**ADDISON AIRPORT
BUILDING REPORT**

Facility Information: **Facility Name:** 4400 Glenn Curtiss Drive
Facility Contact: Lisa Pyles **Contact Phone:** 972-450-2878

Accessology Inspector Information:
Inspector: Karen Jackson **Date:** April 17, 2017
Email: kjackson@accessology.com

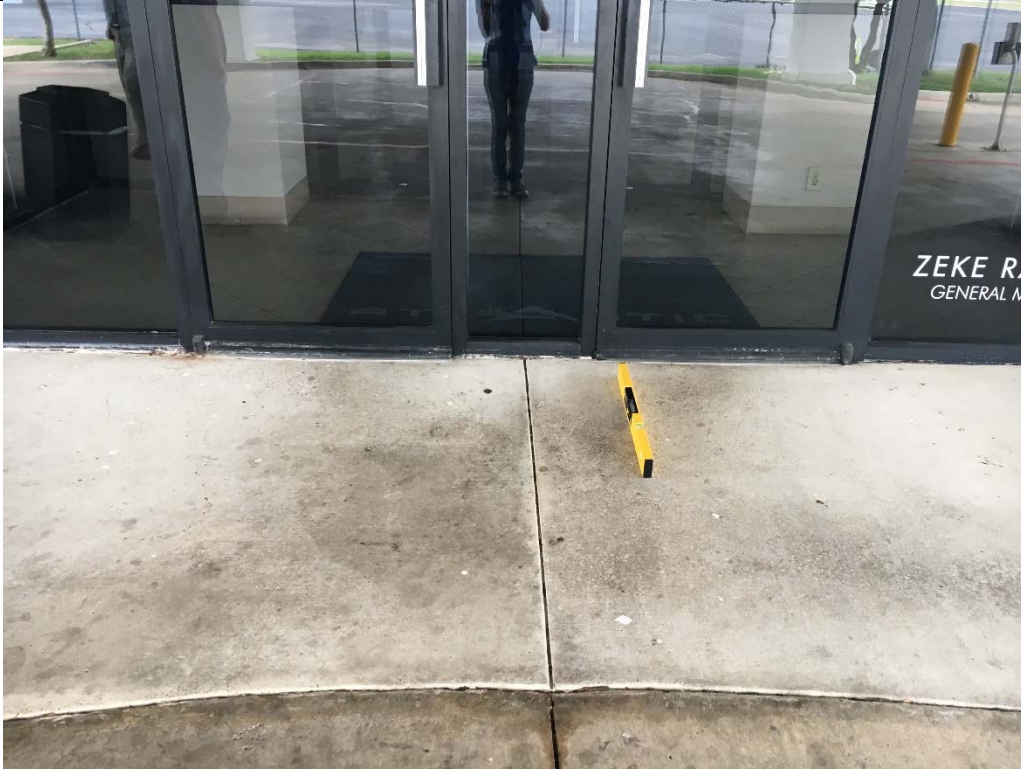
Violation 1 - Only one accessible parking space is provided where two are required and one of the two is required to be van accessible.

Violation 2 - Only one accessible parking space is provided where two are required and one of the two is required to be van accessible.

Violation 3 – There is no accessible parking signage provided.

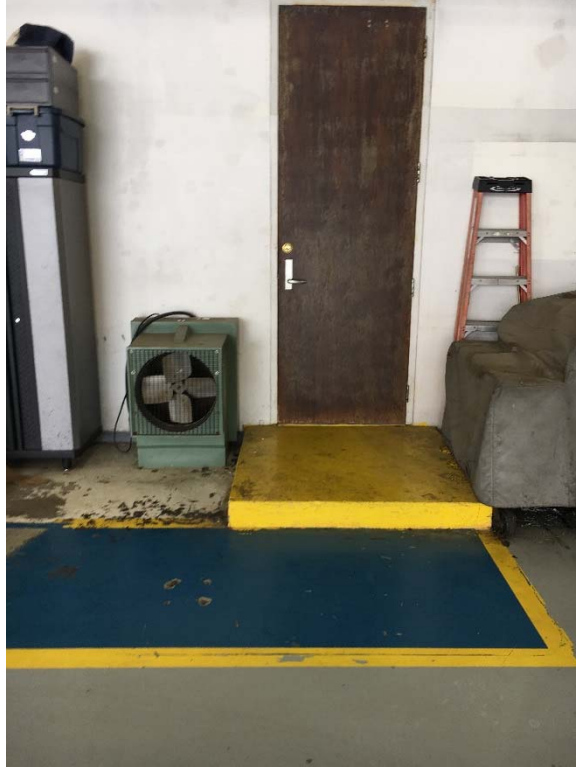
Violation 4 - There is no accessible route leading to the second floor.

Violation 5 - The landing at the building's main entrance has a 6.9% running slope.

Violation 6 - There is only a 33-1/2" deep level landing/maneuvering clearance at the side door that leads to the runway area. The maneuvering clearance at this door should be a minimum of 60" deep.

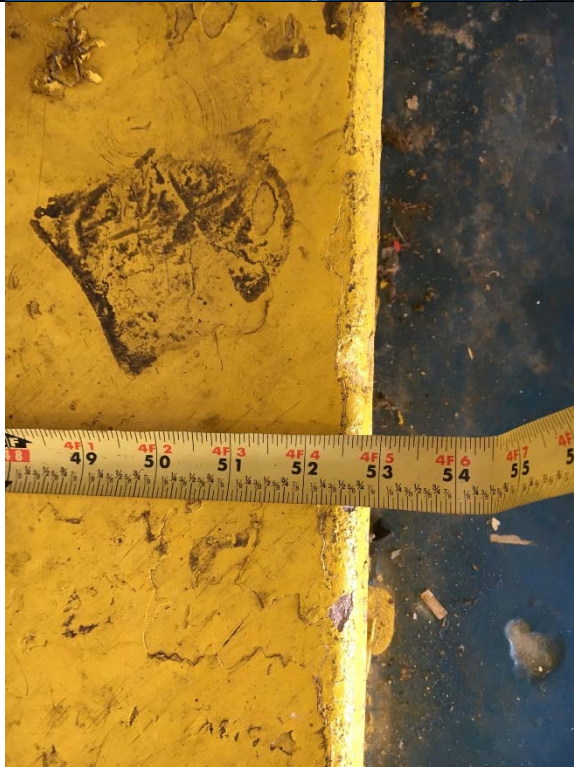
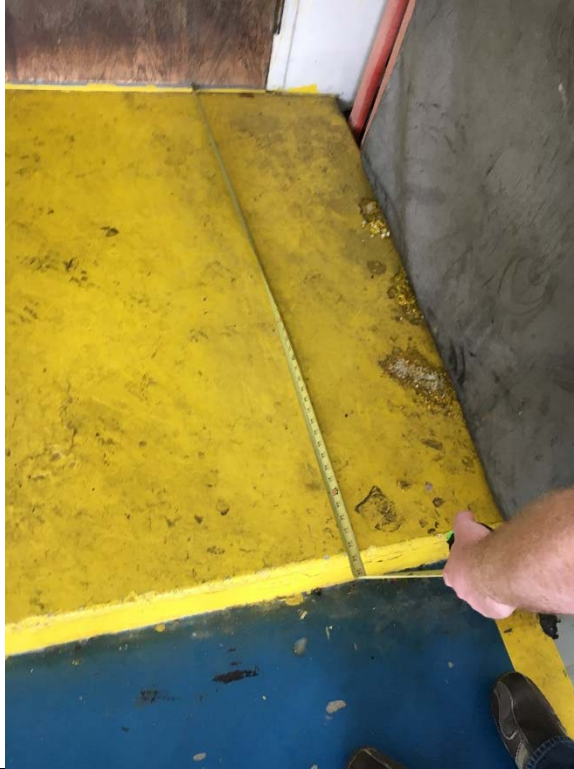
Violation 7 - The sidewalk leading up to the side entrance from the runway area has a 10.7% running slope.

Violation 8 - There are 5 doors leading into the building from the warehouse that have a 6" step up onto a platform.

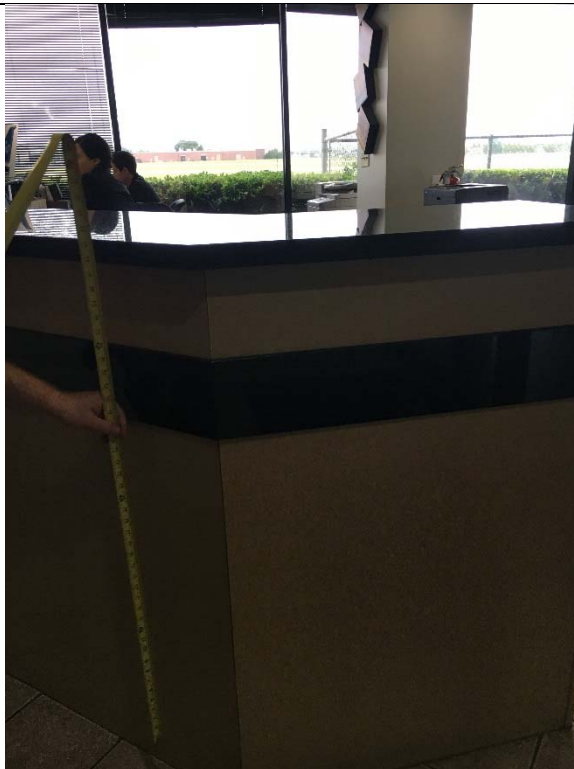
Violation 9 - The warehouse doors only have a 53" deep maneuvering clearance where a minimum of 60" is required.

Violation 10 - Doors leading into the building from the warehouse only have a 9-1/2" maneuvering clearance on the pull side where a minimum of 18" is required.

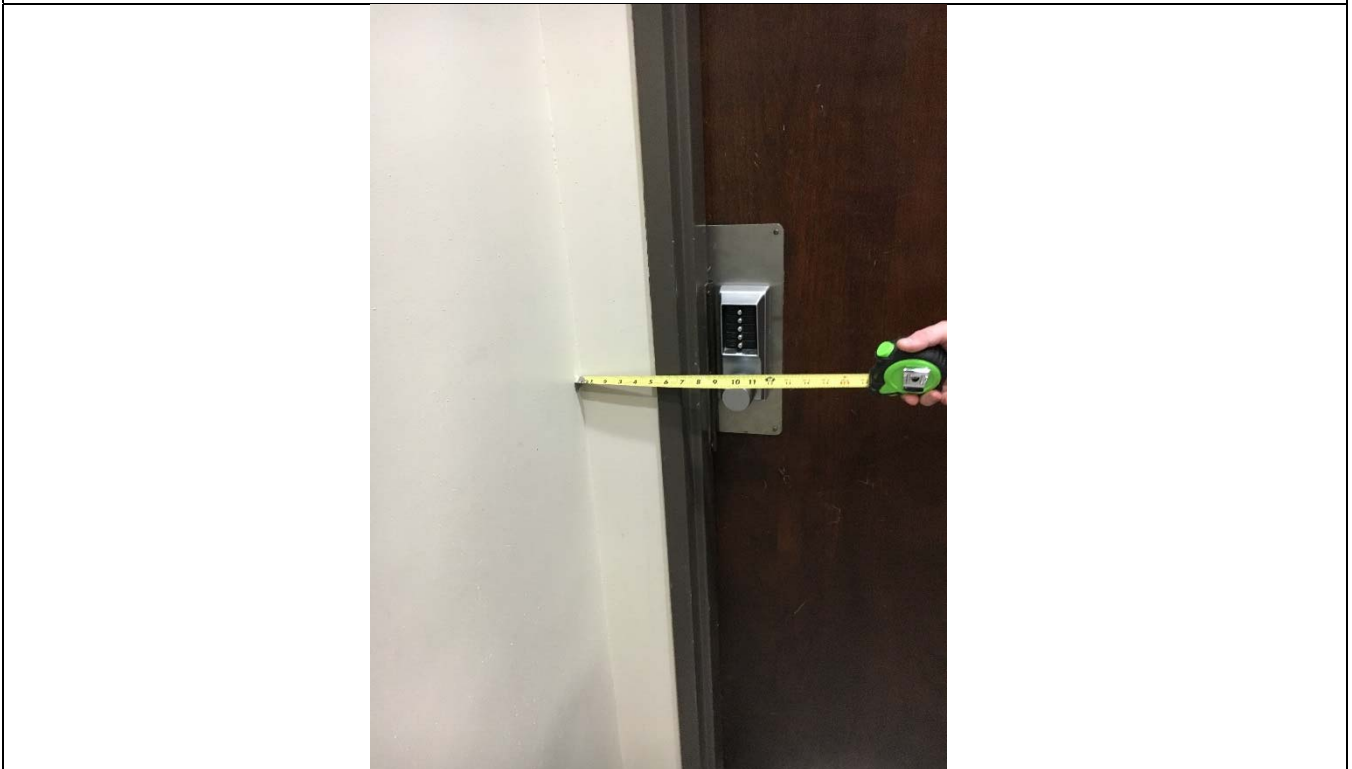
Violation 11 - Doors leading into the building from the warehouse do not have a minimum width of 32".

Violation 12 - The information desk is at 49-3/4" to the top where a maximum of 36" is required.

Violation 13 - Approximately 15 doors throughout the facility have door hardware that requires grasping and twisting to operate.

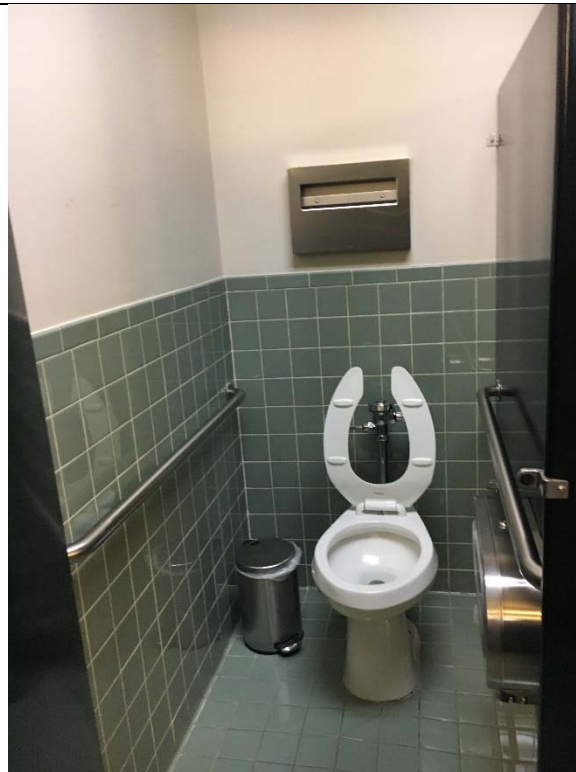
Violation 19 - The lounge restroom does not have an accessible stall provided.

Violation 20 - First Floor Men's room - Does not have an accessible stall provided.

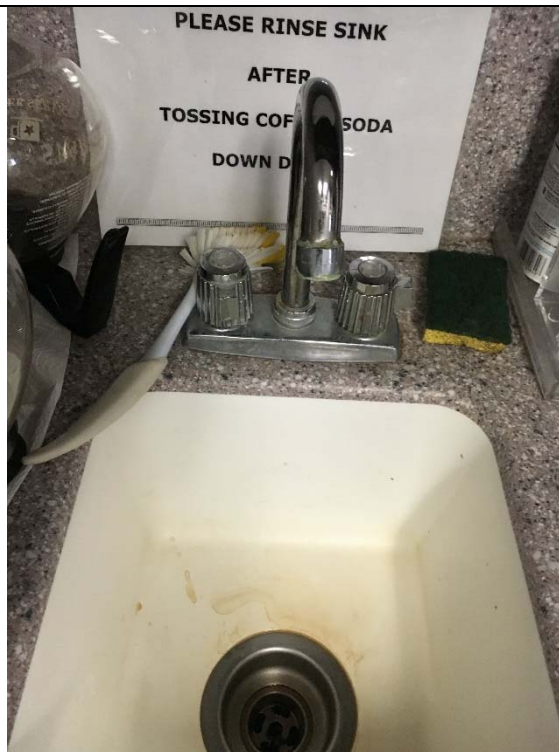
Violation 30 - The warehouse restroom does not have an accessible lavatory provided.

Violation 31 - The counter in the first floor break room is 36-5/16" above finished floor to the top of the counter at the sink where a maximum of 34" is required.

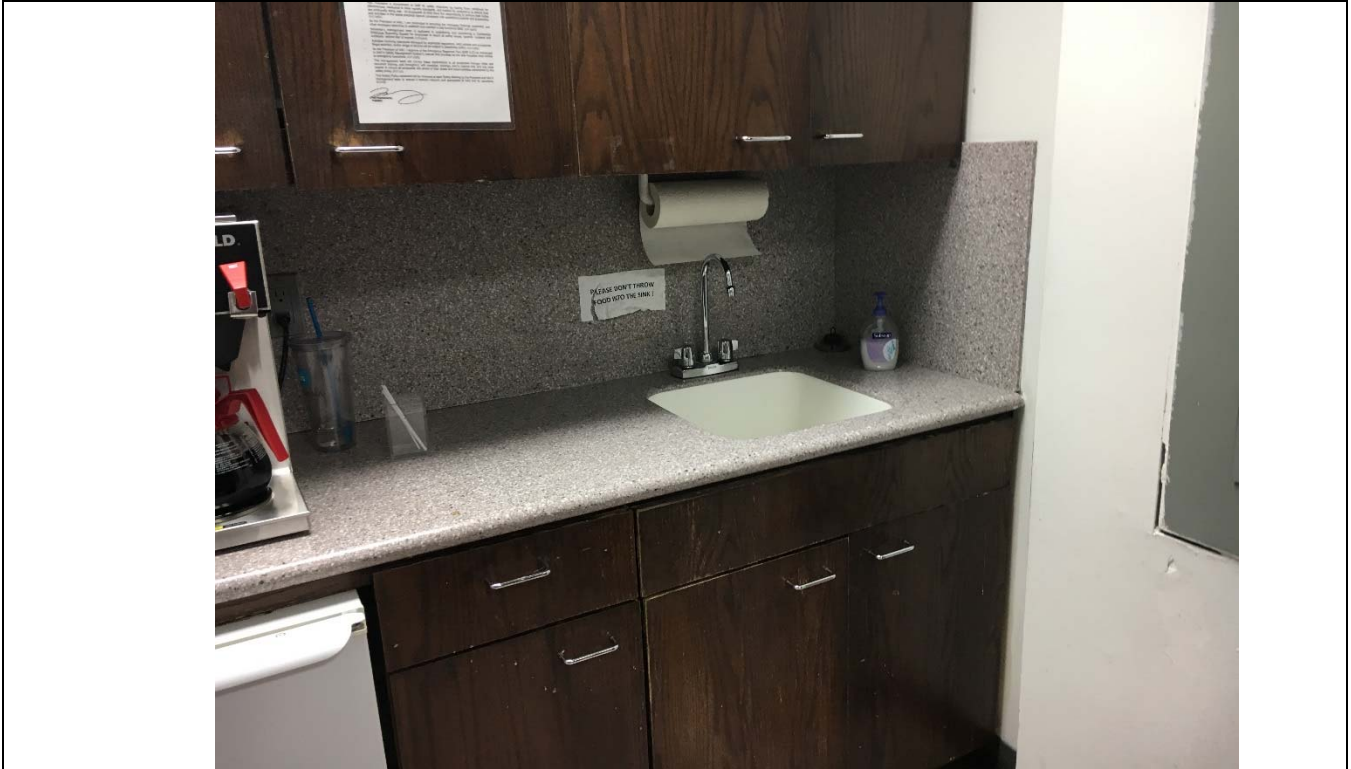
Violation 32 - There is a coffee bar in the AmeriStar Human Resources office (suite 100) with a sink that is mounted at 36" above finished floor where 34" maximum is required.

Violation 33 - The sink controls at the coffee bar in AmeriStar's Human Resources office require grasping and twisting of the wrist to operate.

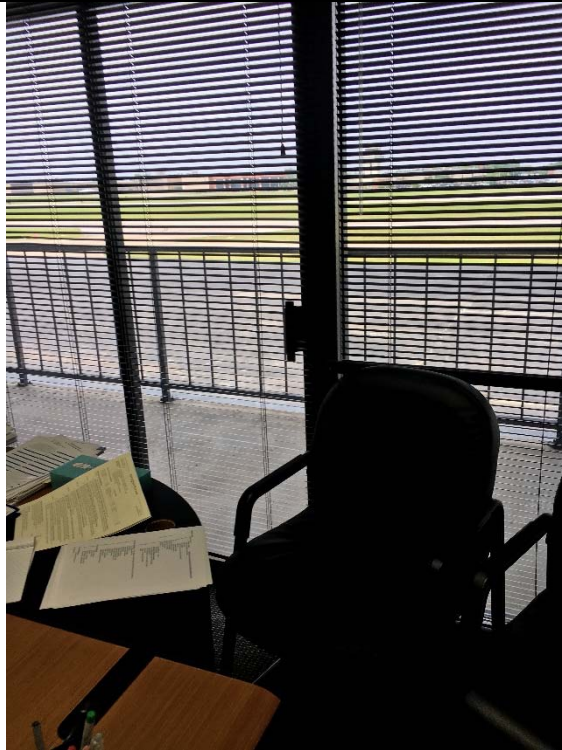
Violation 40 - There is only one drinking fountain provided on the first floor, where two are required.

Violation 41 - There is only one drinking fountain provided on the second floor and it has no compliant features.
